Key Largo Wastewater Treatment District Board of Commissioners Meeting Agenda Item Summary

Subject:
Change Order No. 1 for Collection System Monitoring Project

Re: KLWTD Collection Monitoring System- Change Order #1

**SECTION 00950
CHANGE ORDER FORM**

Concrete Pad Thickness:

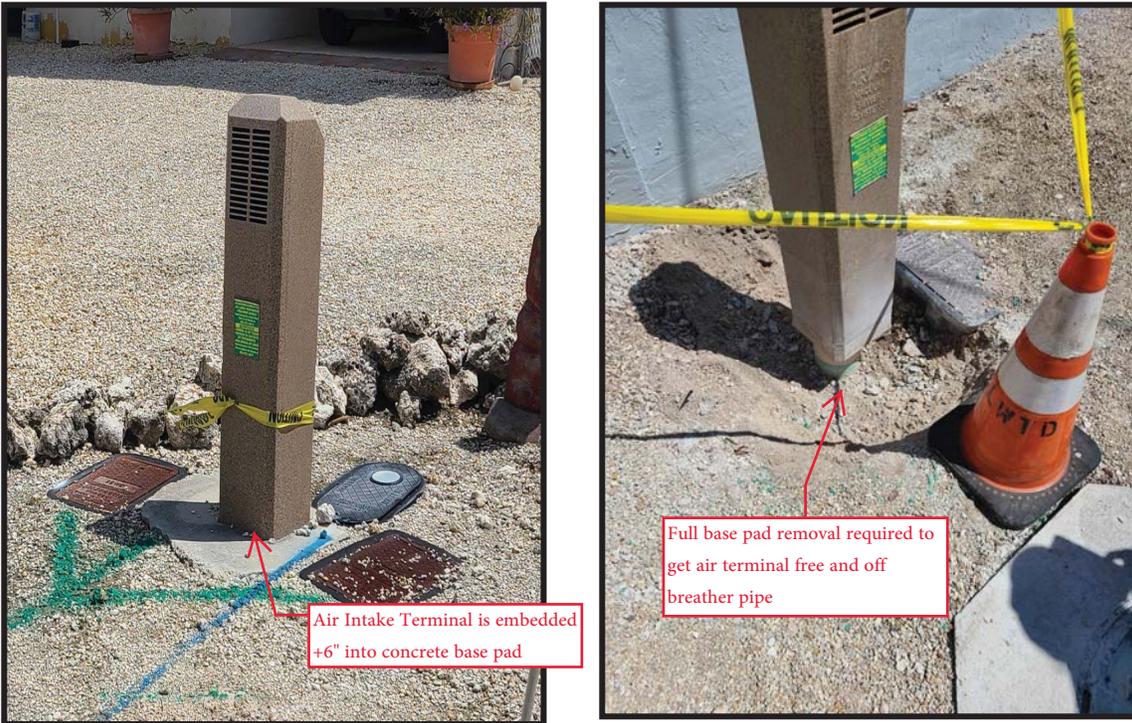
The first issue encountered was the thickness of the house keeping pad under the air intake terminals (tombstones). Typically, these housekeeping pads are expected to be 4”-6” thick with minimal reinforcement which is what was planned for as part of the Collection System Monitoring project. However, in Basin D it was quickly discovered that the housekeeping pads were 16”-24” thick. This thickness meant that FloVac’s plan of under excavating the pad and coring a hole for the 2” conduit through it would no longer be possible as it would require drilling through +16” of concrete.

As can be seen in the pictures above, the concrete had to be chipped out in order to get the conduit installed. In Basin D there were 205 of the 240 pits that required this additional chipping work.

The second issue encountered was that some of the air intakes were embedded approximately 6” into the concrete housekeeping pads and could not be removed without breaking the pad apart. As with the aforementioned pads, these were also 16”-24” thick but because of the embedment it required full removal of the pad to complete the installation of the FloVac sensors & conduits.

The picture above (left) shows an air intake terminal embedded in the concrete. The other picture above (right) shows the terminal after the pad has been removed. In Basin D there were 35 terminals that were discovered to be embedded in the concrete which require full removal of the pad.

As discussed above, in Basin D 205 of the 240 total air intake terminals were poured too thick and required additional effort for the Contactor to install the system. Additionally, 35 of the 240 air intake terminals were embedded approximately 6” into the concrete which required full pad removal resulting in additional effort. This additional effort was beyond what was expected based on project records and design standards. The contractor should be compensated for the work beyond the original scope of the project.

Increasing Breather Height:

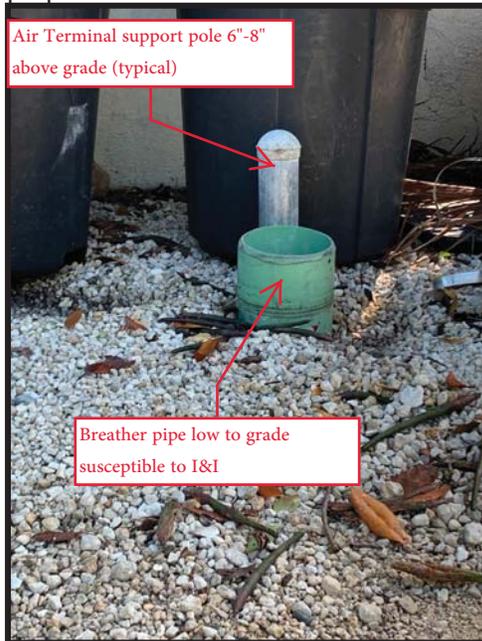
The breather pipe is the pipe located inside the air terminal that allows air into the vacuum system. It is a crucial part of the system operation. As the air intake terminals were being removed it was noted that several of the pipes were very low to the ground. In a normal environment this may not be an issue but in coastal flood prone areas such as Key Largo, the low elevations mean that water can enter the pipe during large storm events, king tides, as well as storm surge events.

It is recommended that as a hardening effort these pipes be extended 24” above grade in the coastal flood prone areas. KLWTD staff has identified these areas and a pit count was taken. It was determined that approximately 870 breather pipes should be raised to lessen the chances of inflow and infiltration to the system.
